**An Evaluation of Flood Frequency Analyses for the Skagit River,
Skagit County, Washington**

**Federal Emergency Management Agency
Region X
Bothell, Washington**

**February 26, 2010
Revised May 19, 2010**

Figure 2. Flood frequency curve for regulated peak discharges observed by USGS at Concrete compared with the HEC-RAS simulated regulated peak flows at Concrete (Figure 21 from PIE (2008)).

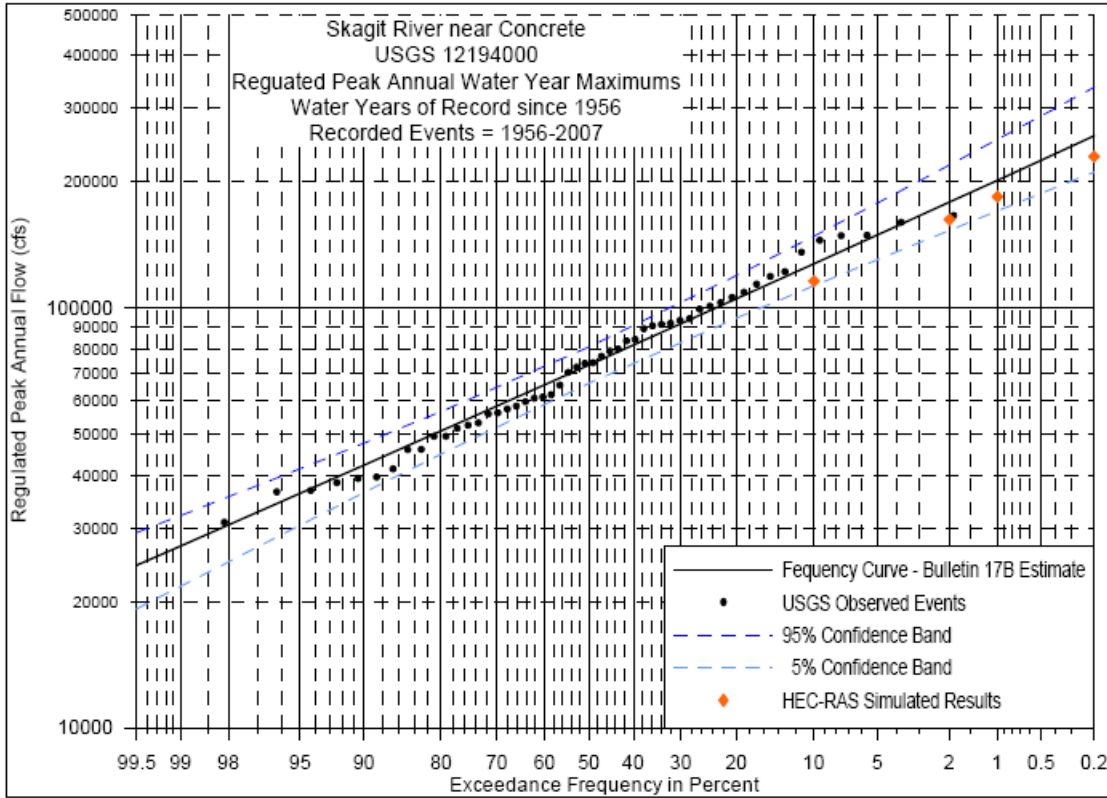
The HEC-RAS routed flows in Figure 2 for the 10-, 2-, 1- and 0.2-percent chance floods are less than the regulated frequency curve based on the observed record from 1956 to 2007. The unregulated flood hydrographs that were routed to give the HEC-RAS simulated results in Figure 2 were based on the four historic floods and other unregulated peak data from 1925 to 1955. The PIE (2008) estimates of the four historic floods have been significantly reduced from those published by USGS and their impact on the regulated frequency curve is now minimal.

Figure 3. Comparison of unregulated and regulated frequency curves for the Skagit River near Concrete, WA as developed by PIE (2008).

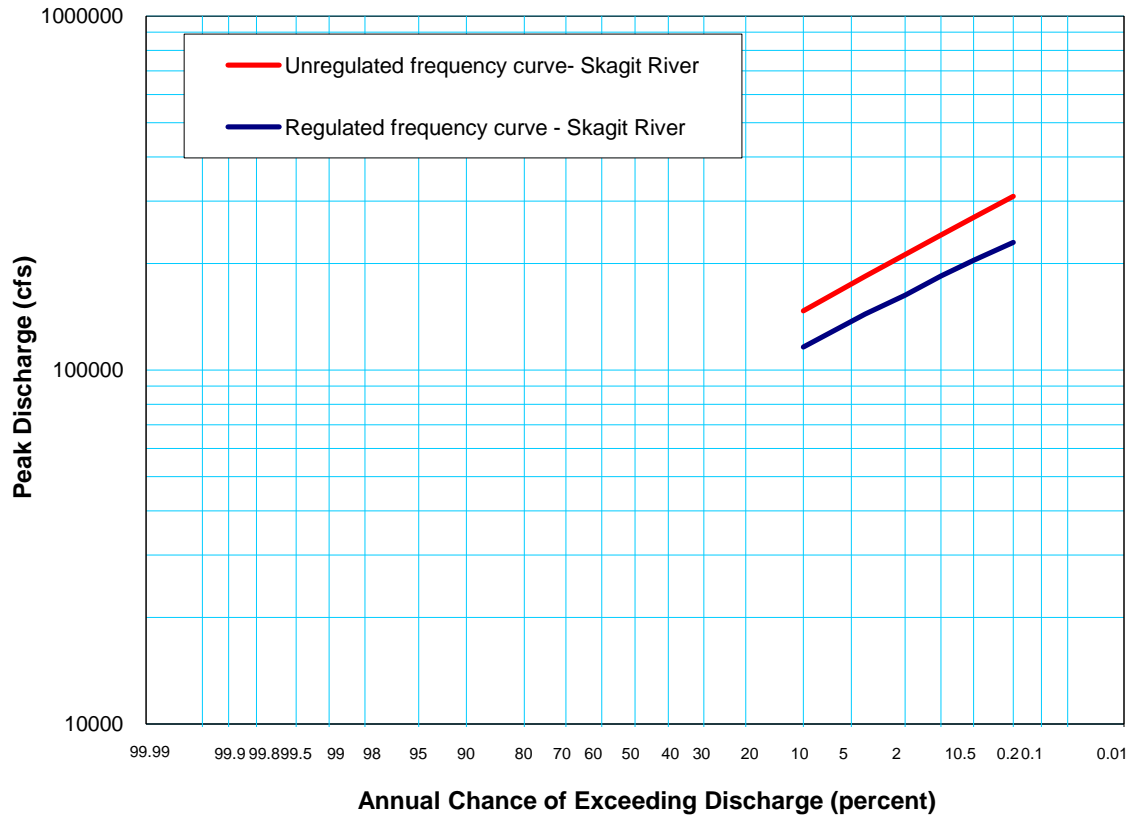
As shown in Table 3, the ratio of the regulated to unregulated flood discharges for the PIE analysis is actually decreasing as the flood event becomes more extreme while the USACE ratio increases as it should. As the magnitude of the flood event increases and the flood storage in the reservoirs decreases, the regulated and unregulated flood discharges should converge. At the 0.2-percent annual chance event, the PIE (2008) unregulated and regulated frequency curves are still diverging. This is illustrated in Figure 3. The skew for the PIE (2008) regulated frequency curve is about -0.35 and -0.142 for the unregulated curve implying they are diverging.

The diverging of the regulated and unregulated frequency curves was prevalent in an earlier 2005 analysis performed by PIE. This issue was discussed in a February 2006 review by FEMA. In response to the FEMA 2006 review, PIE pointed out that their 2005 frequency curves would converge at about 4 times the 1-percent annual chance flood discharge. This may also be the case for the PIE (2008) analysis that the frequency curves will converge for some very large flood event. However, it seems the PIE (2008) regulated and unregulated frequency curves should be converging for a large flood like the 0.2-percent chance flood given the dedicated flood storage (71 acre-feet per square mile) in the Skagit River watershed.

Figure 4. Comparison of unregulated and regulated frequency curves for the Skagit River near Concrete, WA as developed by USACE (2008).

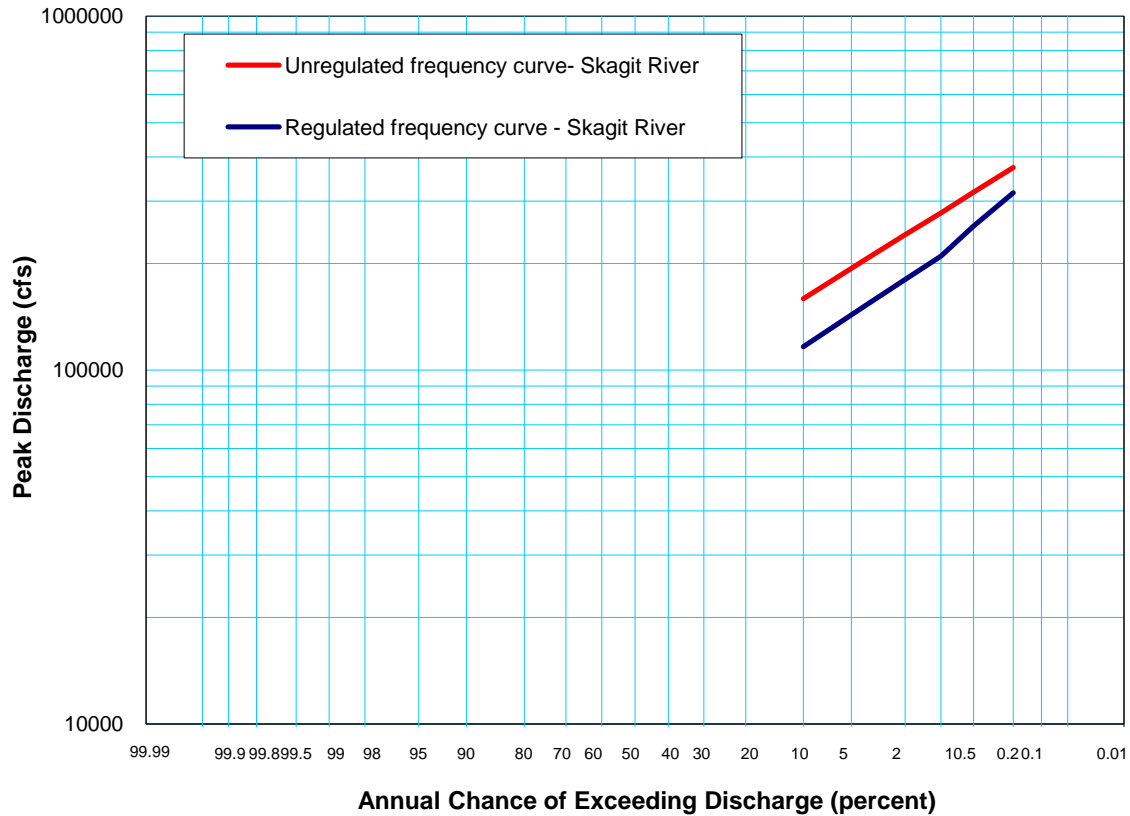
This is the case for the USACE (2008) analyses as shown in Table 3 and in Figure 4. The skew for the USACE (2008) regulated frequency is about 2.0 and 0.0 for the unregulated curve implying the frequency curves are converging.
